## Addendum No. 1

Project: BCC Ciccone Theatre Roof Replacement

**ROOF PLAN  
METAL FENCE & GATE PLAN & ELEVATIONS  
STOREFRONT ELEVATION & DETAILS**

**A.101**

**1 ROOF PLAN**  
SCALE: 1/16" = 1'-0"

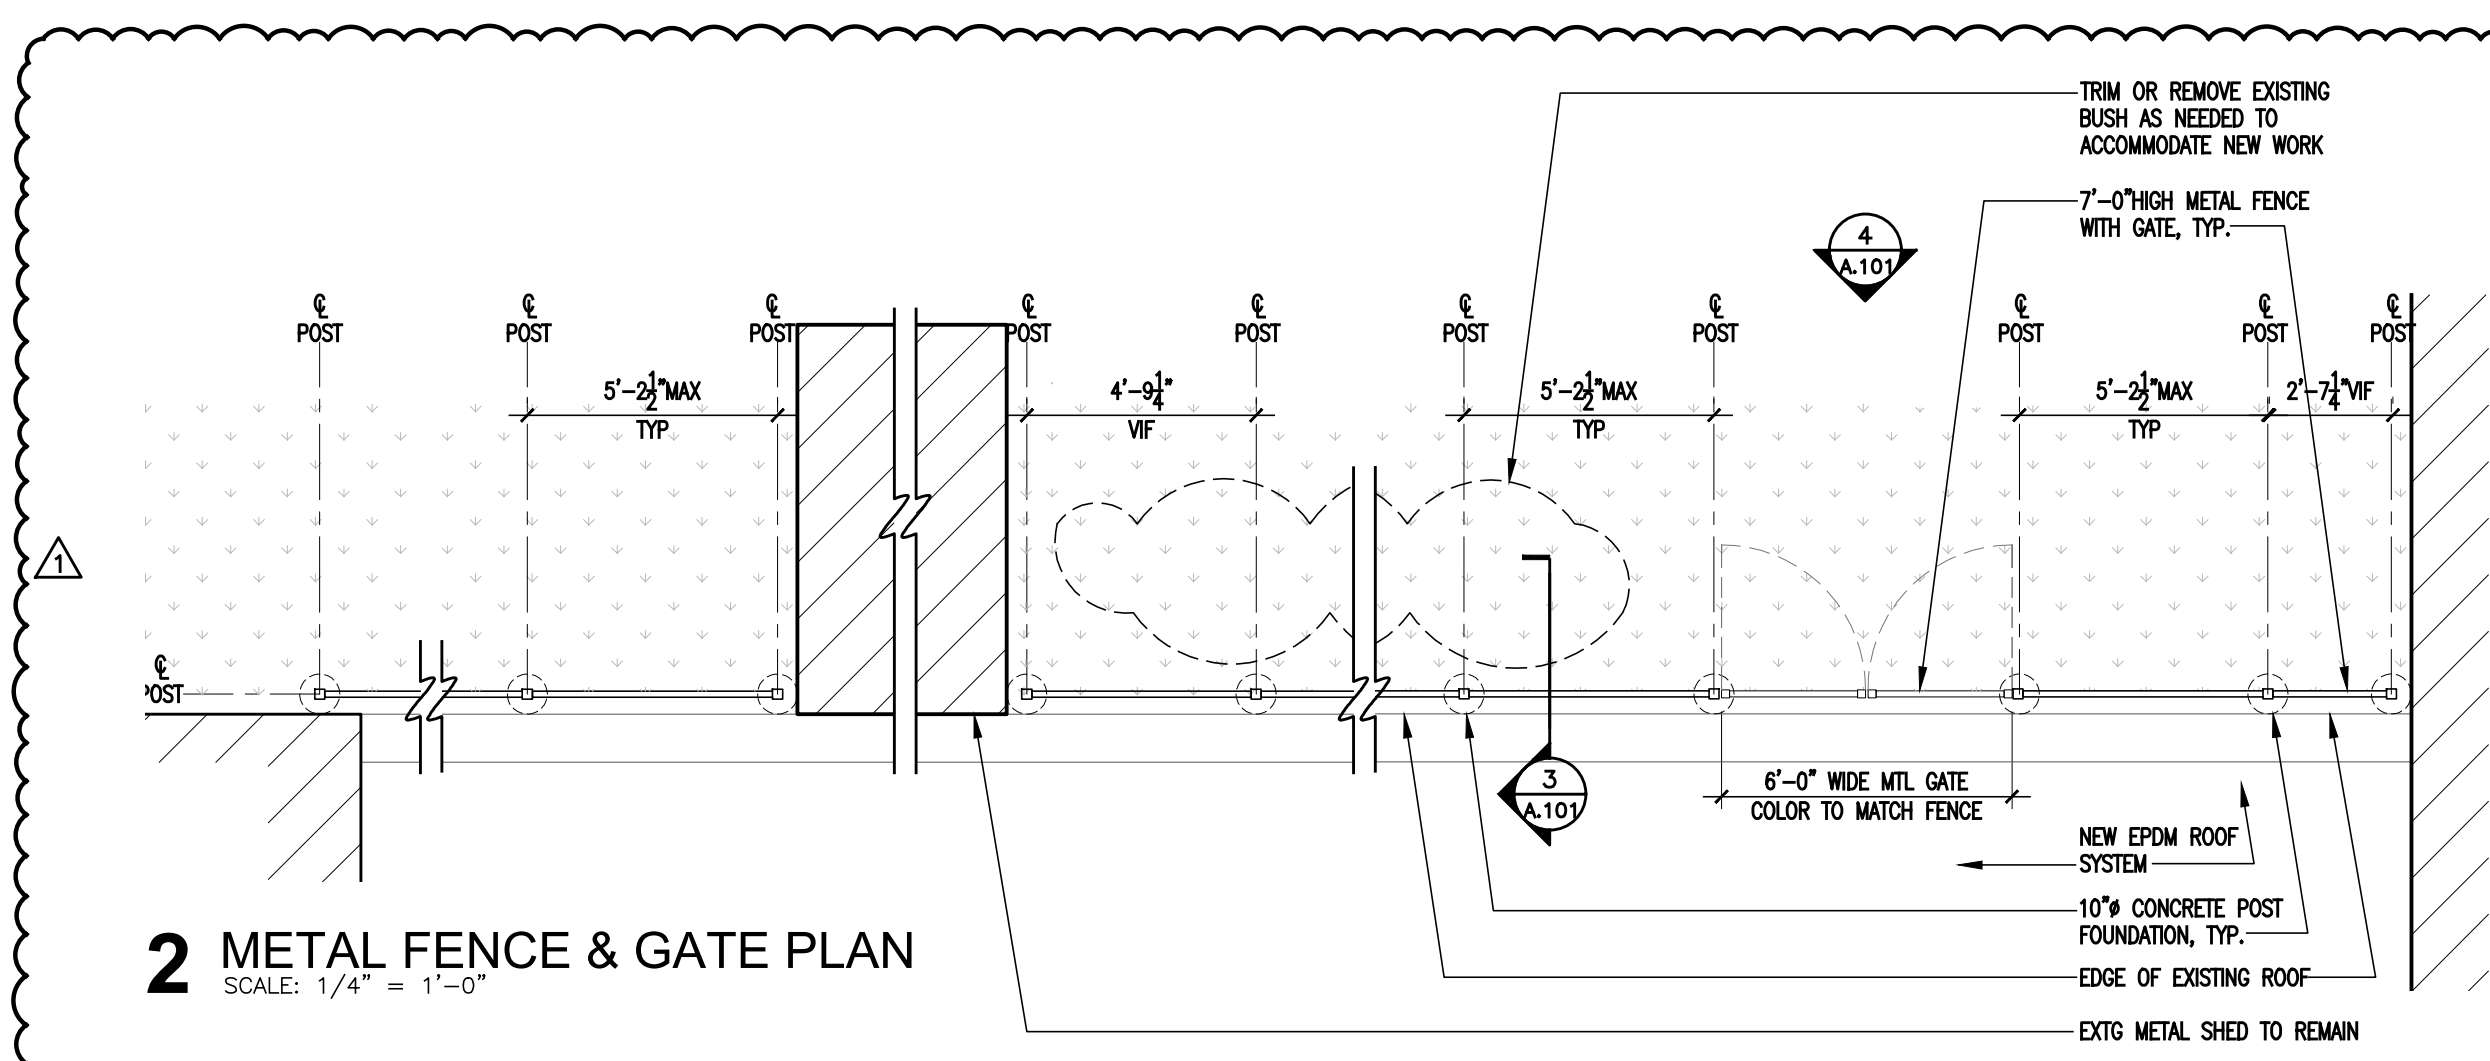
- Item #1 Sheet A.101 Roof Plan, Metal Fence & Gate Plan and Elevations, Storefront Elevation & Details
- a. The Scope of Work of new metal fence has changed as shown in DWG.1/A.101 Roof Plan, DWG.2/A.101 Metal Fence & Gate Plan, DWG.3/A.101 Metal Fence Detail, and DWG.4/A.101 Metal Fence & Gate Detail.
